St. Louis Site Expert Geohydrologic Panel

October 5, 1995

QUESTIONS/ACTIONS AND RESPONSES FROM
ST. LOUIS EXPERT PANEL MEETING
SEPTEMBER 15, 1995

Thorium-230 Activity for Soil Samples from St. Louis, MO Site Frequency
Distribution of Thorium-230 Activity

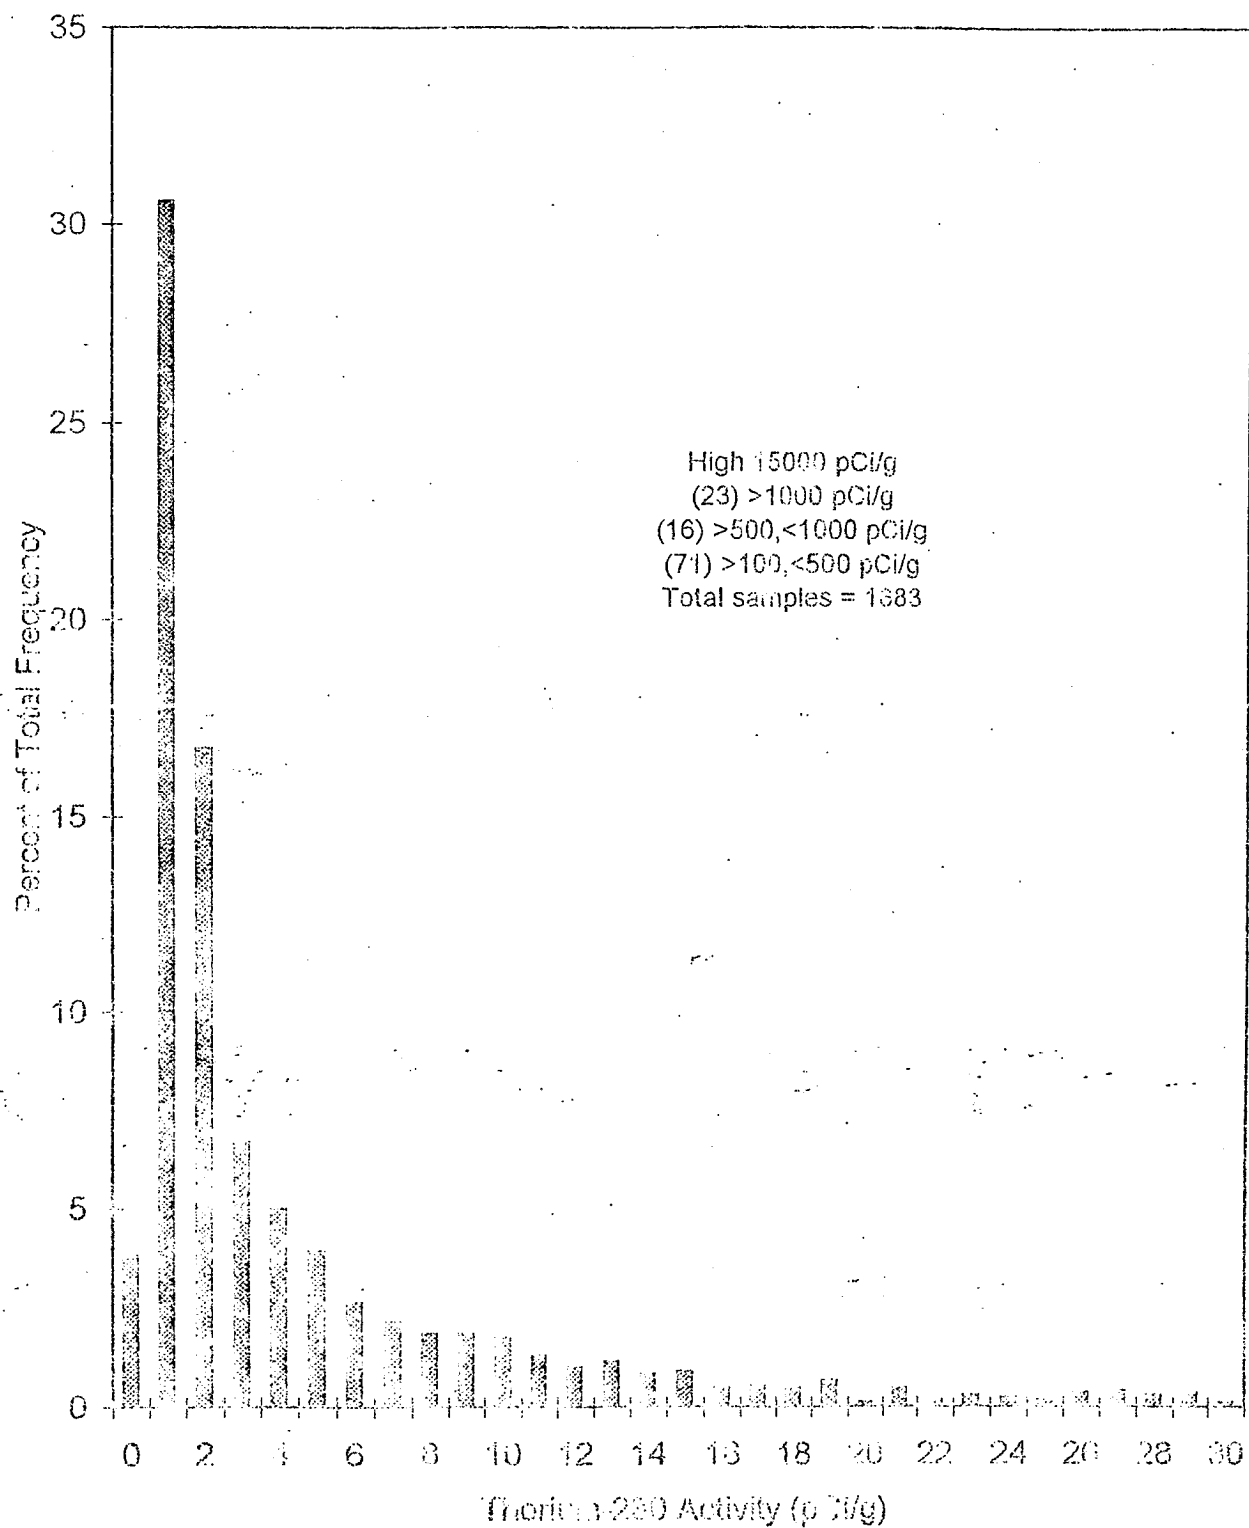
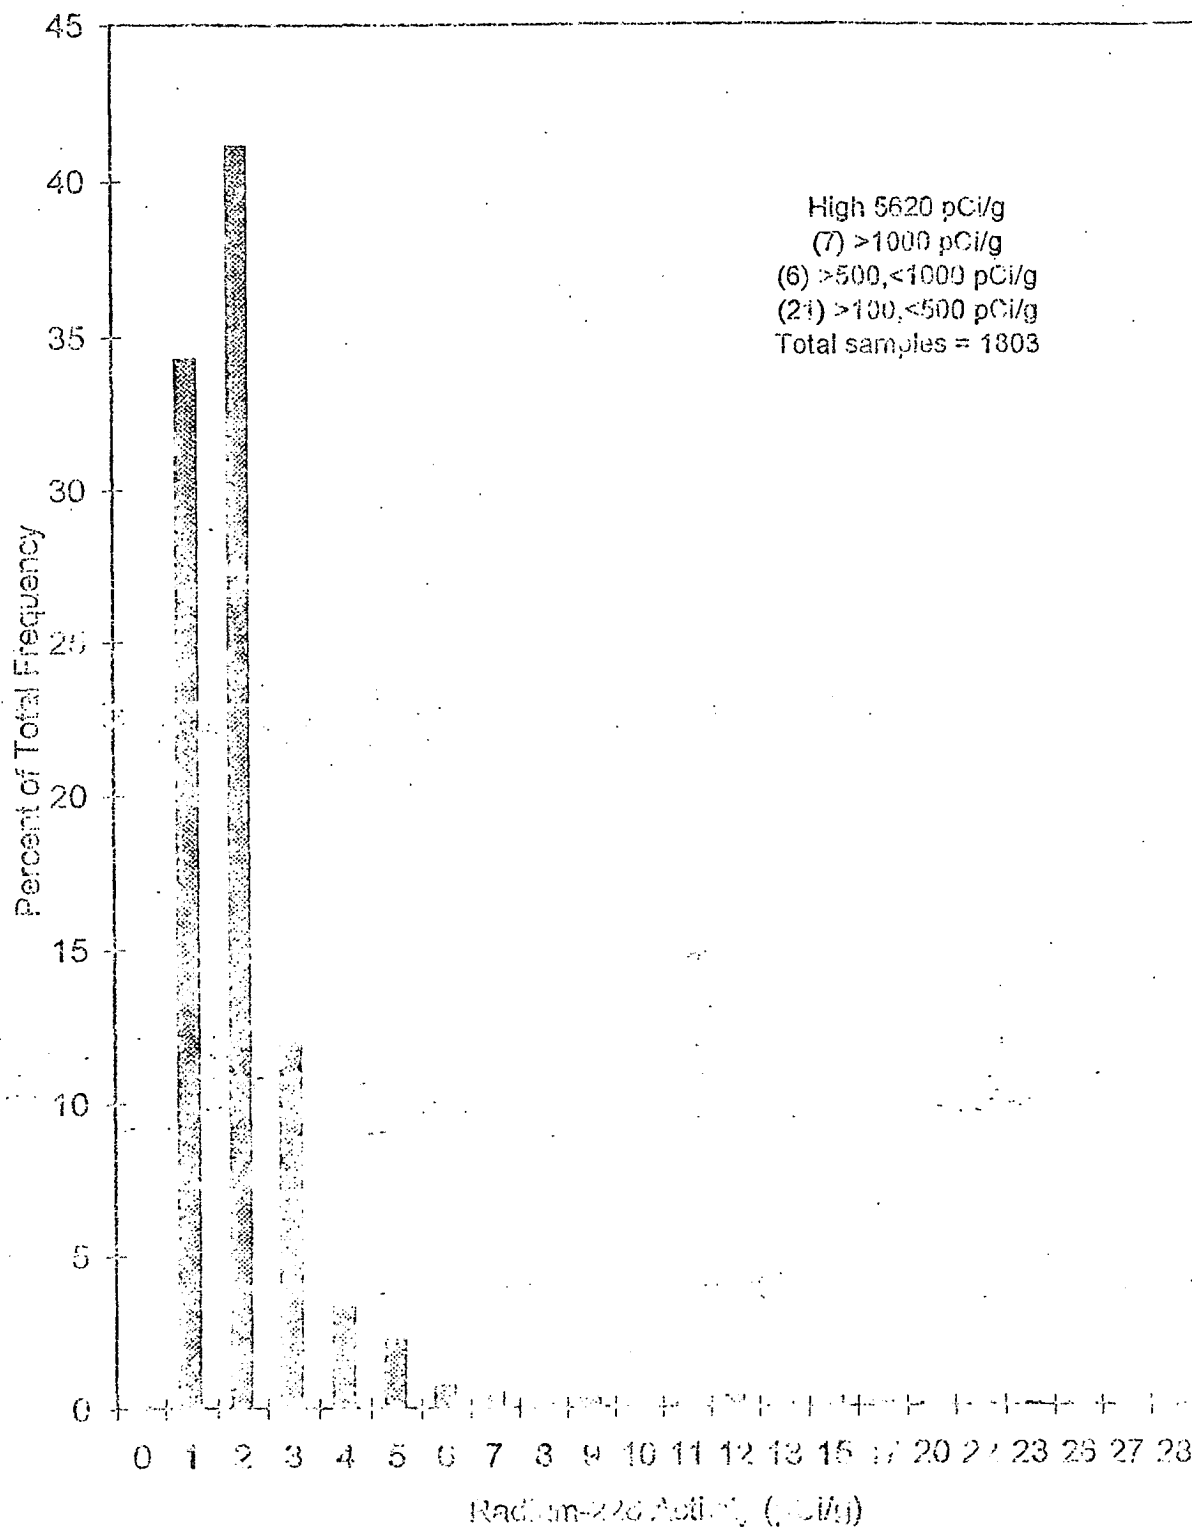
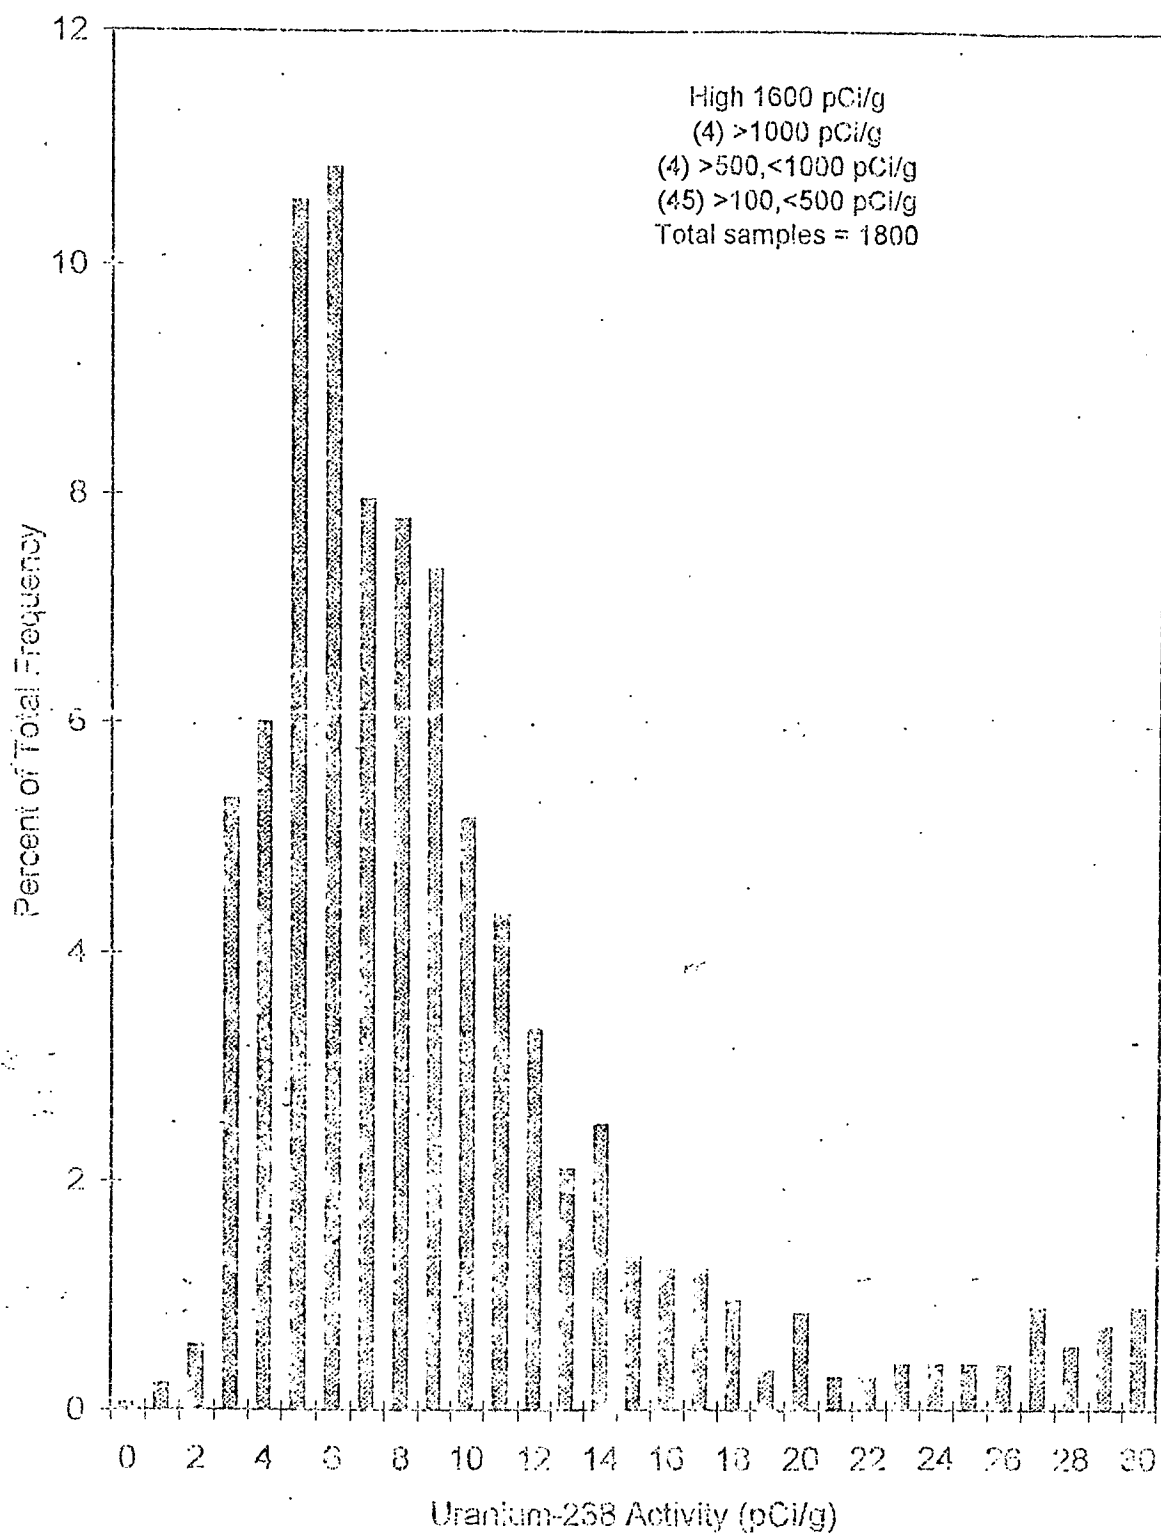
- 12) What is sense of frequency of hits along the creek? (ALEY) (This is where Skinner said that maps have been put together, and Dan Wall described the figure).

Response: A slide will be provided (if a slide projector is available).

Isopach Map of Fill

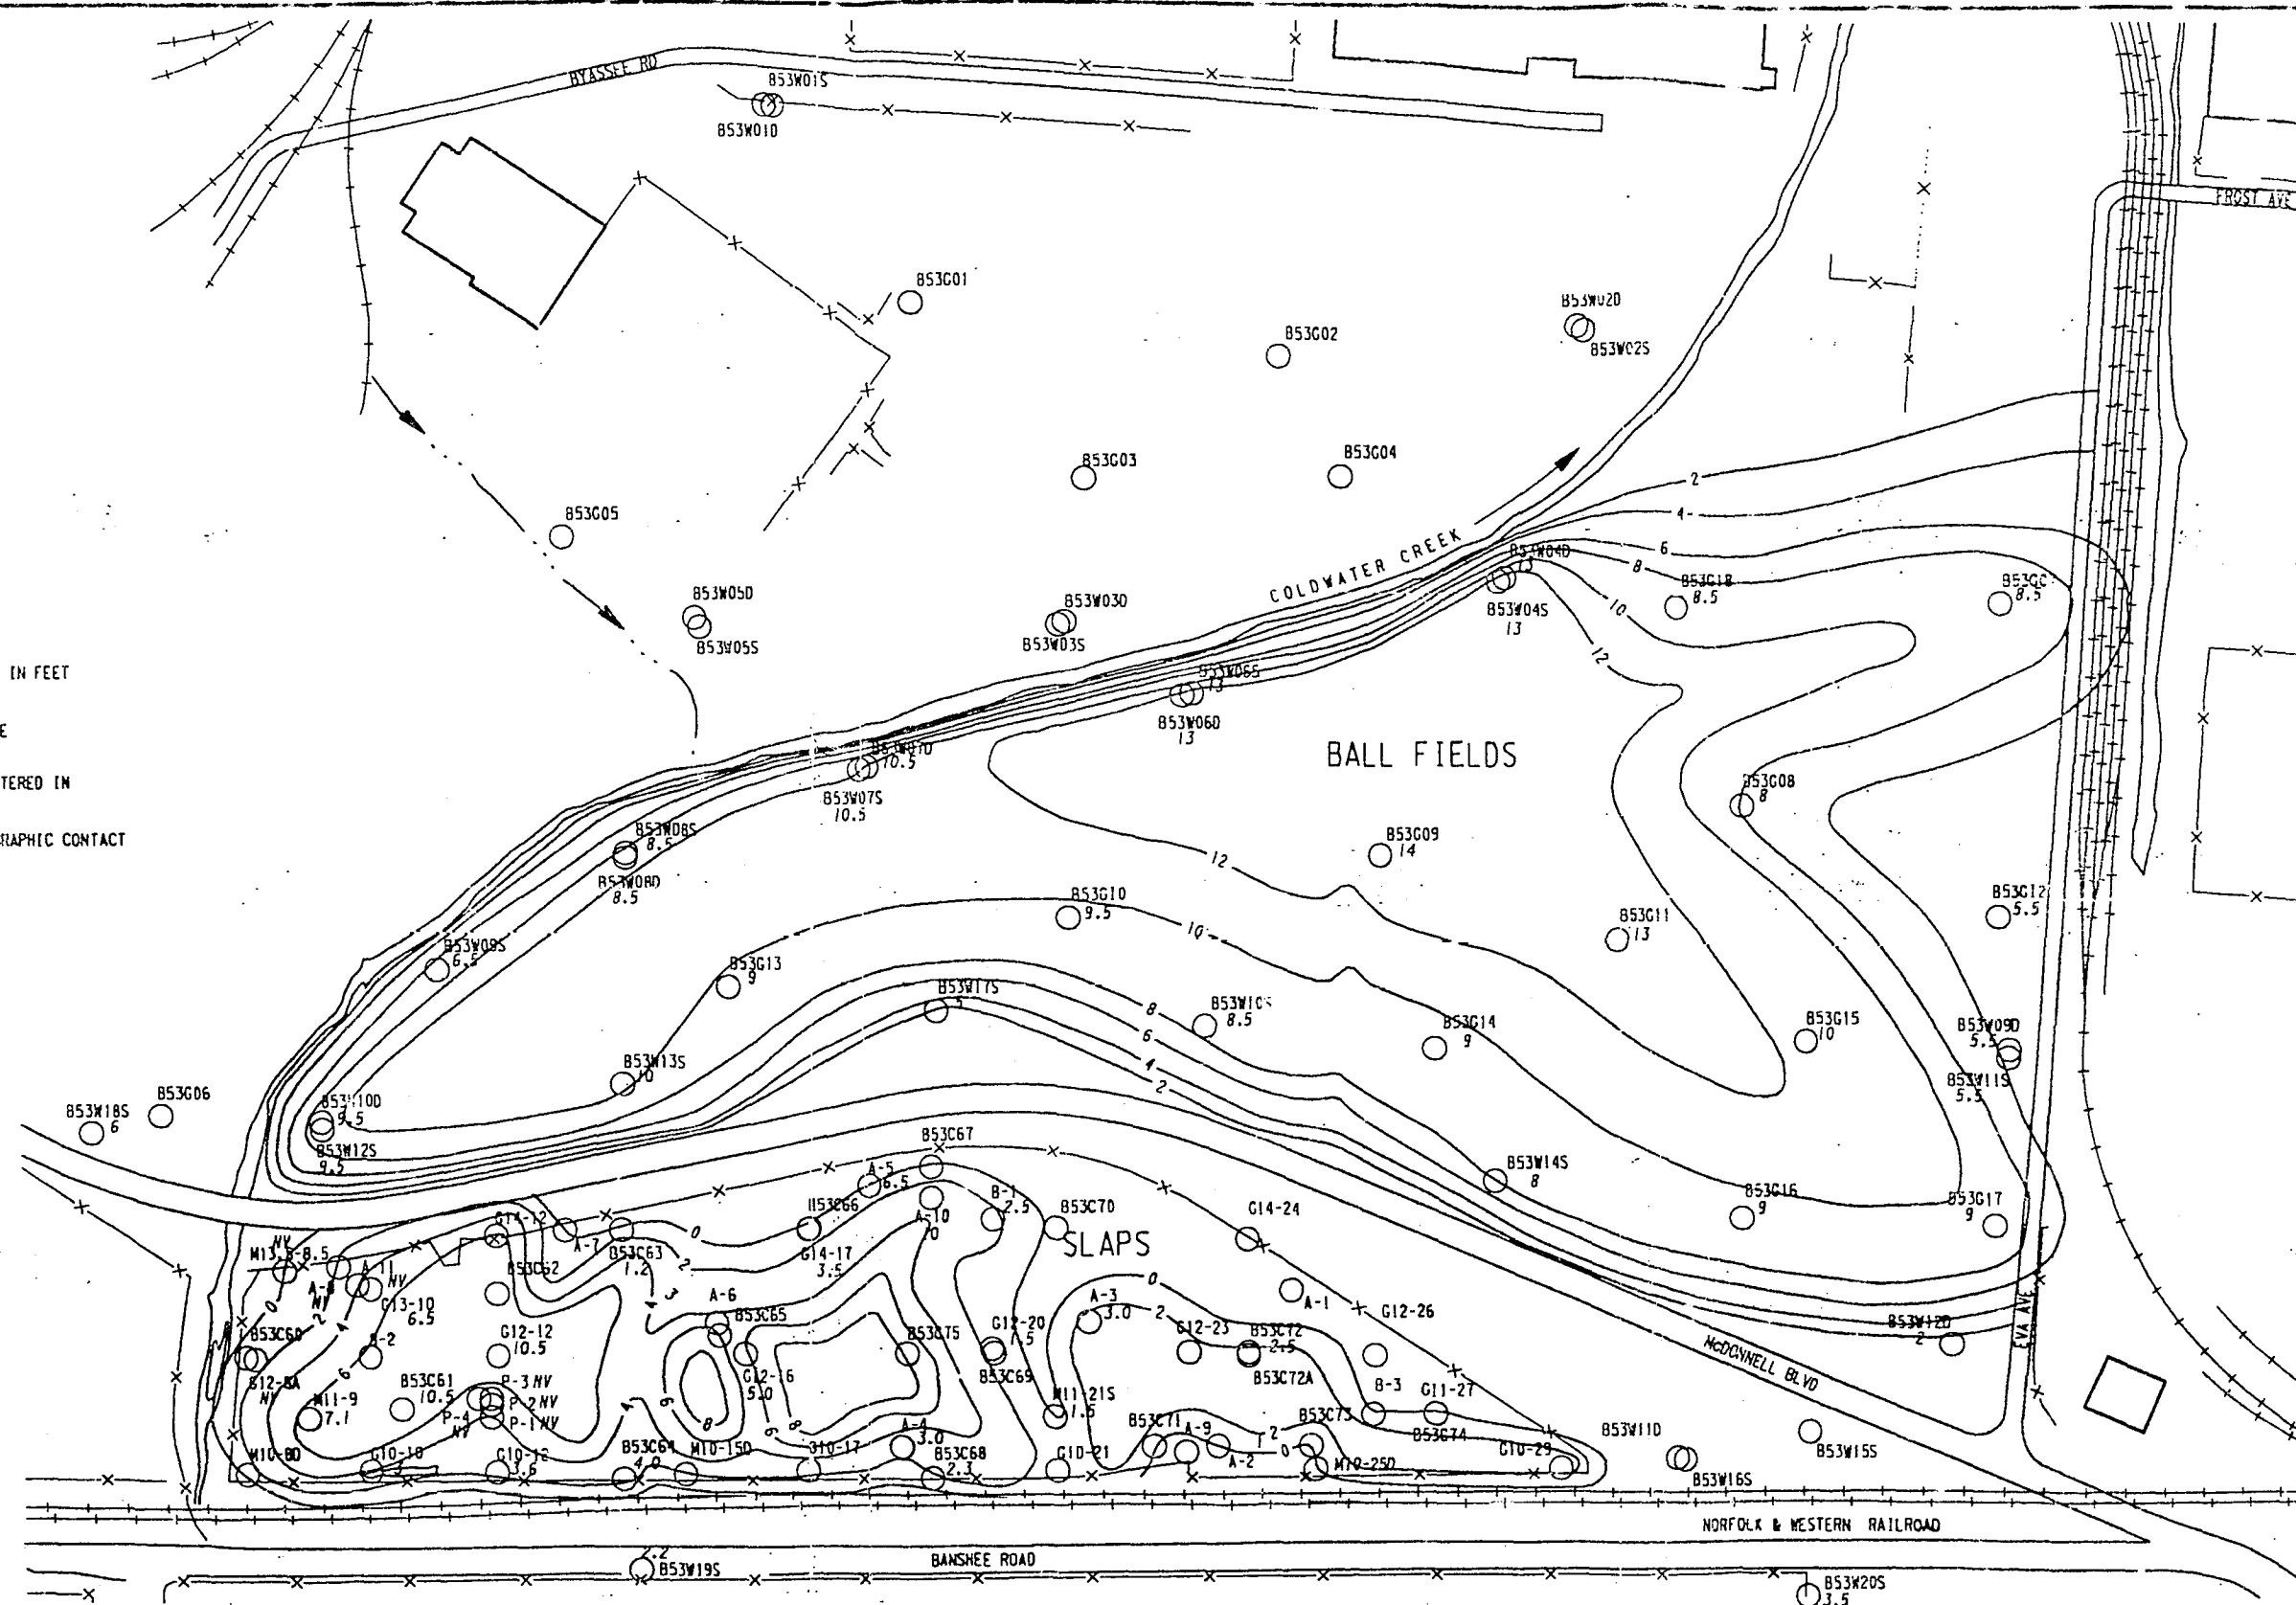
- 5) Were any of the fills brought to SLAPS of low permeability? (ALEY)

Response: The source of the fill could not be determined. A map of the fill texture was constructed based on the geologic log made during the drilling of each borehole. That map is provided. Also included are isopach maps of the estimated fill thickness.
